POP55 modification by K. Arai May 20, 2011

| LSC Photodiode | | LIGO Laboratory California Institute of Technology Massachusetts Institute of Technology | |
| Size: B | DCC Number: D980454-01-C | PCB / SCH Revision: B / 1 | Engineer: J. Suina D. Ouimette |

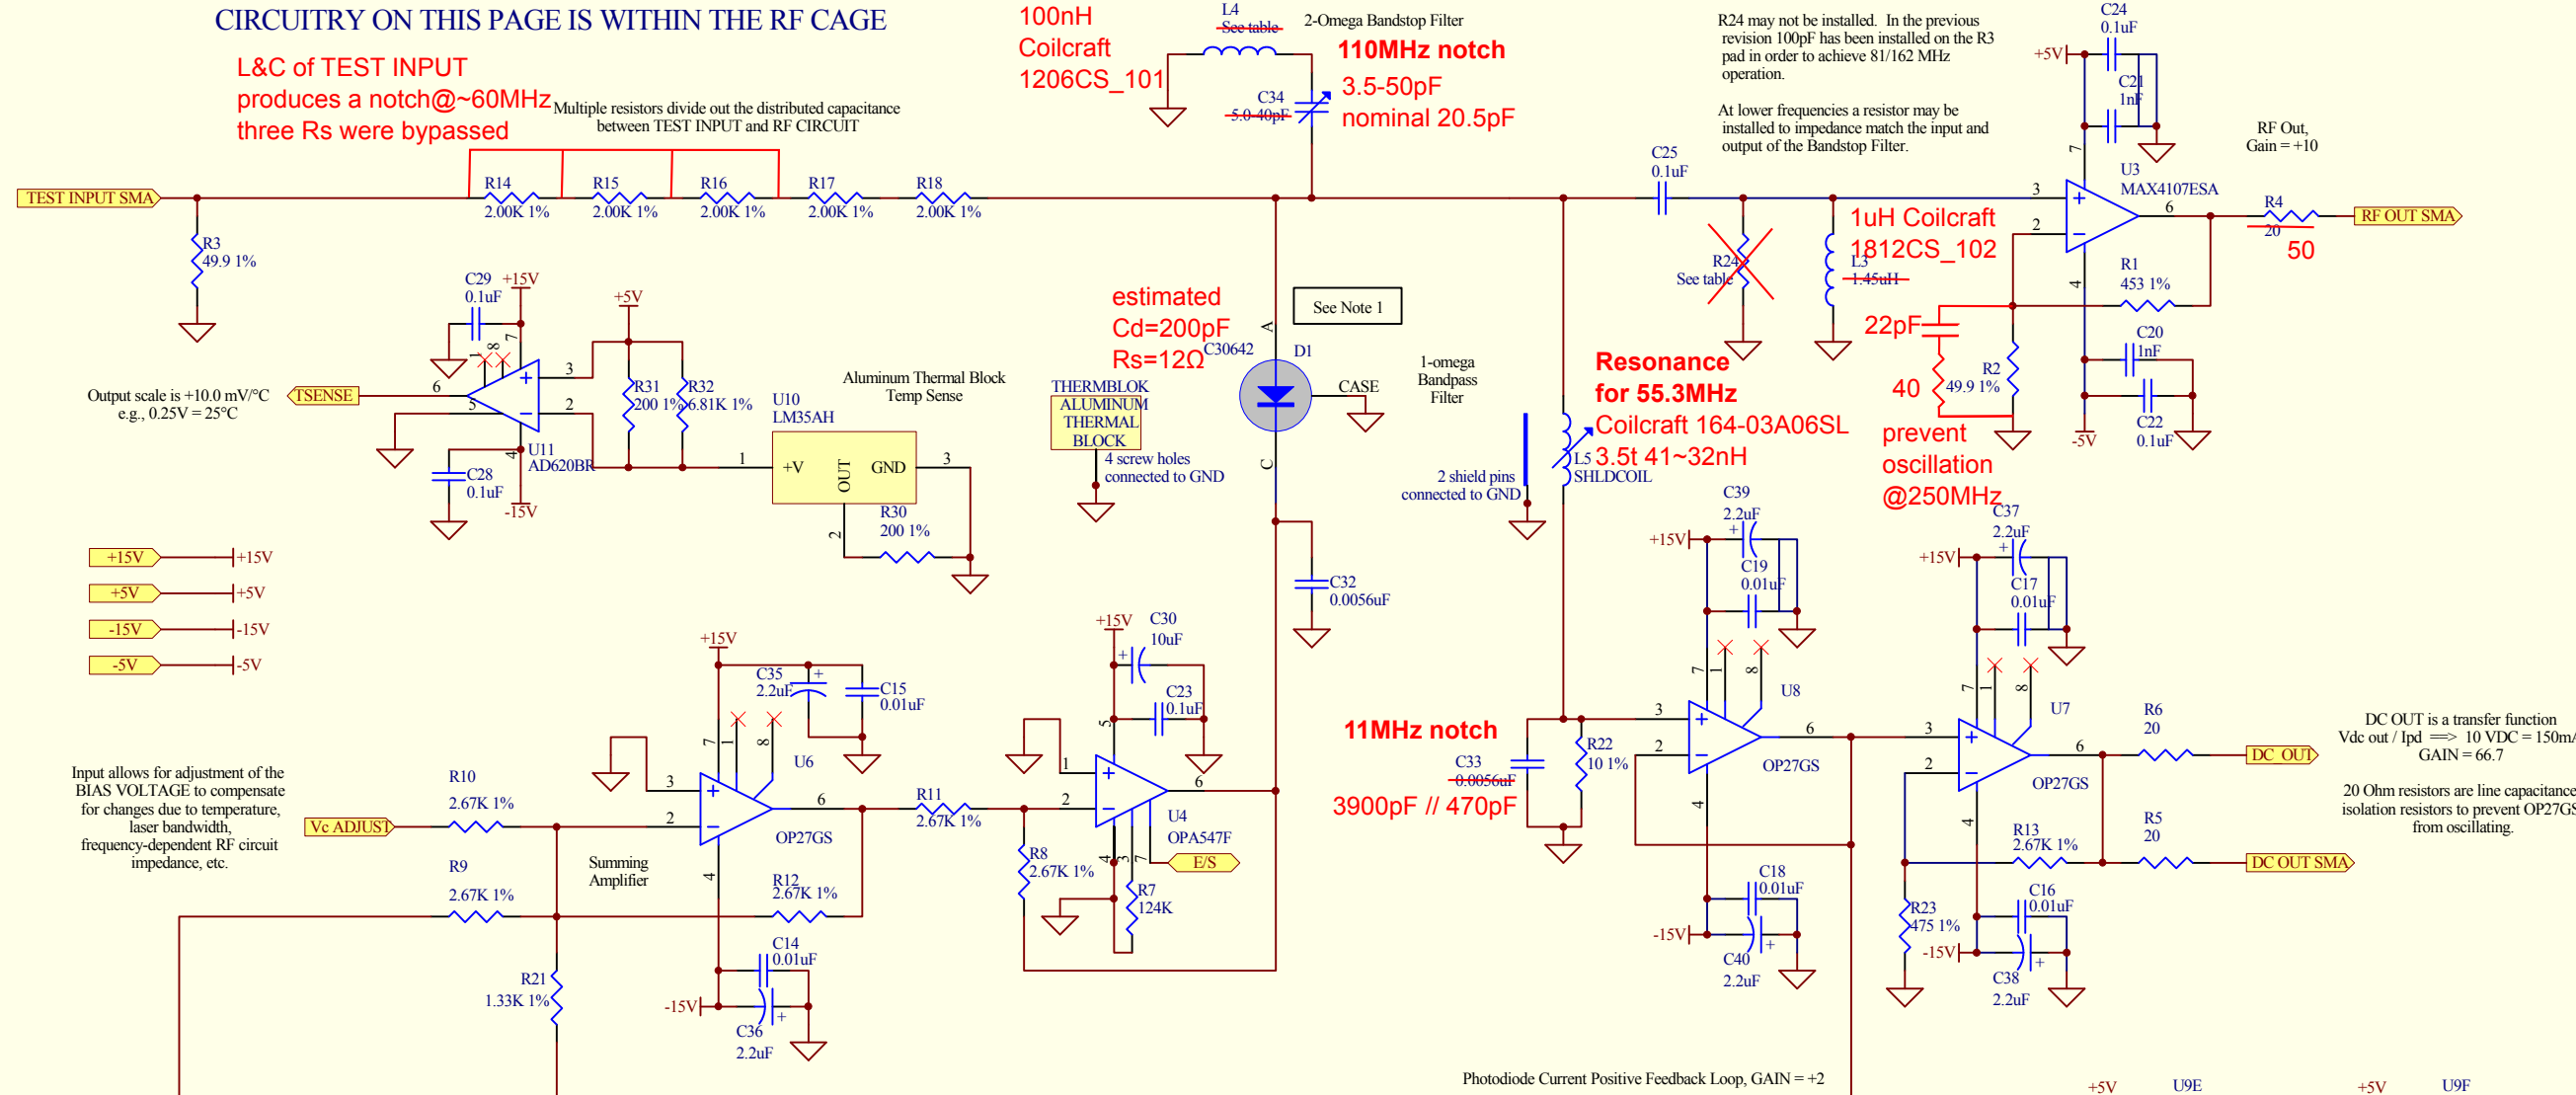
L&C of TEST INPUT produces a notch@~60MHz three Rs were bypassed

Multiple resistors divide out the distributed capacitance between TEST INPUT and RF CIRCUIT

100nH Coilcraft 1206CS_101
110MHz notch
3.5-50pF nominal 20.5pF

R24 may not be installed. In the previous revision 100pF has been installed on the R3 pad in order to achieve 81/162 MHz operation.

At lower frequencies a resistor may be installed to impedance match the input and output of the Bandstop Filter.

POP55 (2011/5/20)

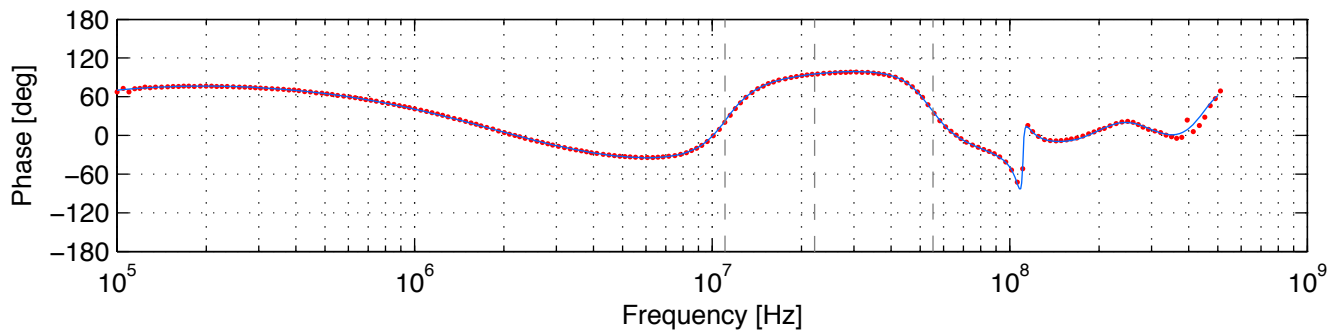
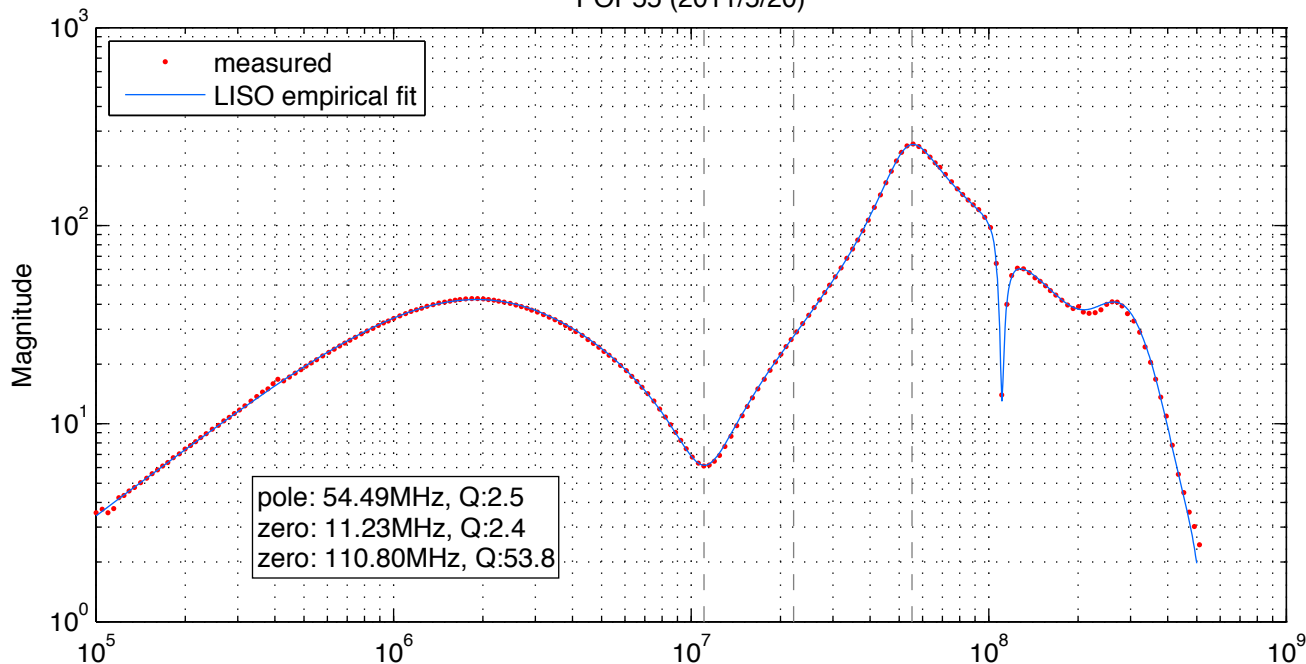
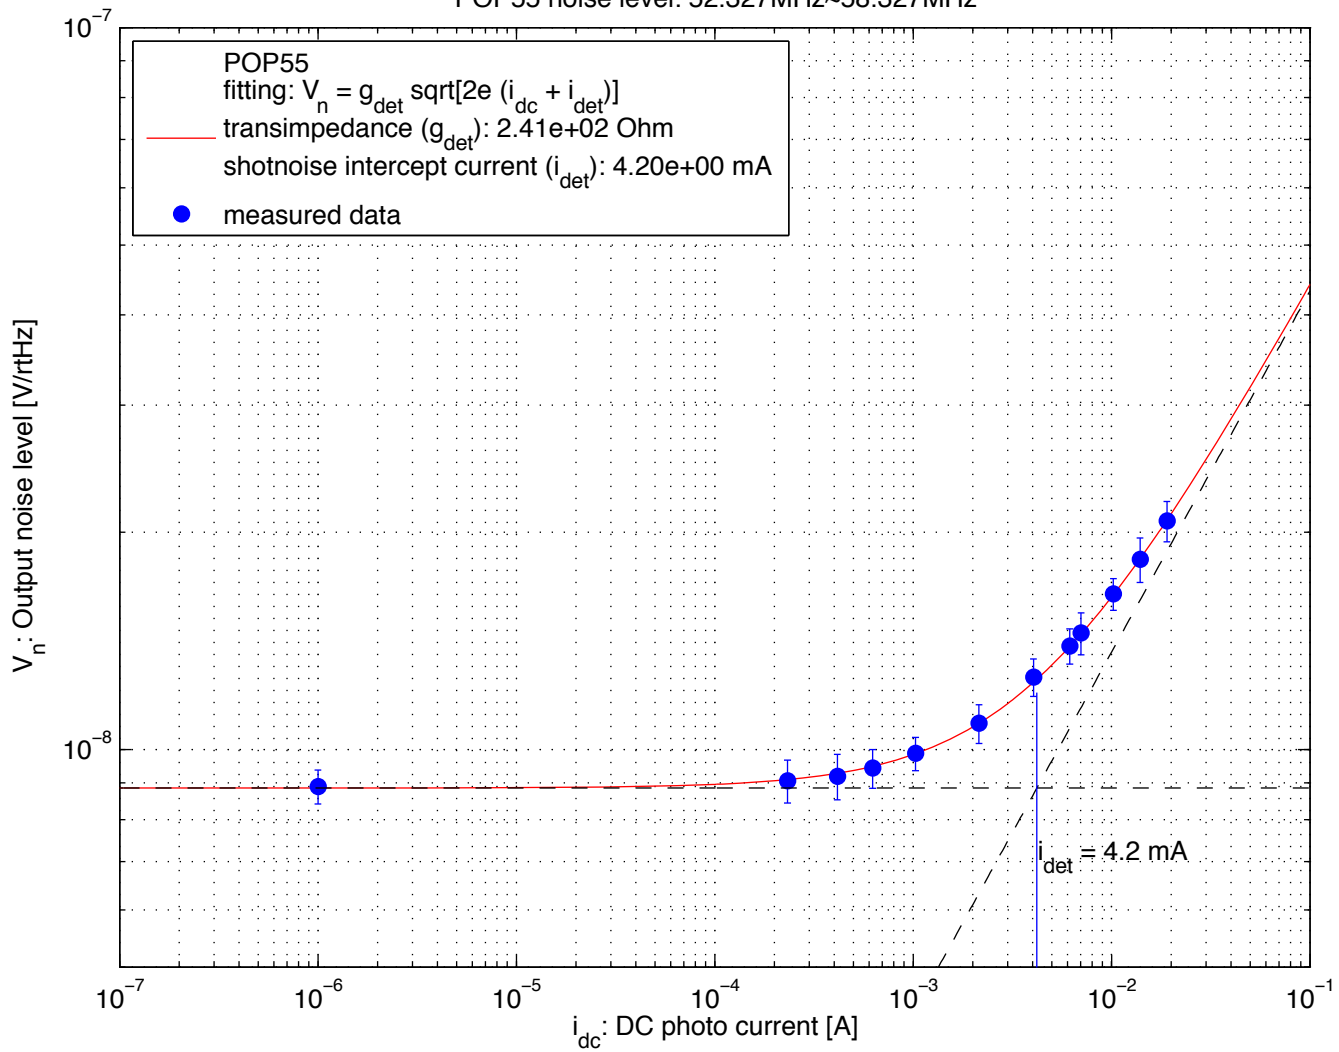
PD current noise level
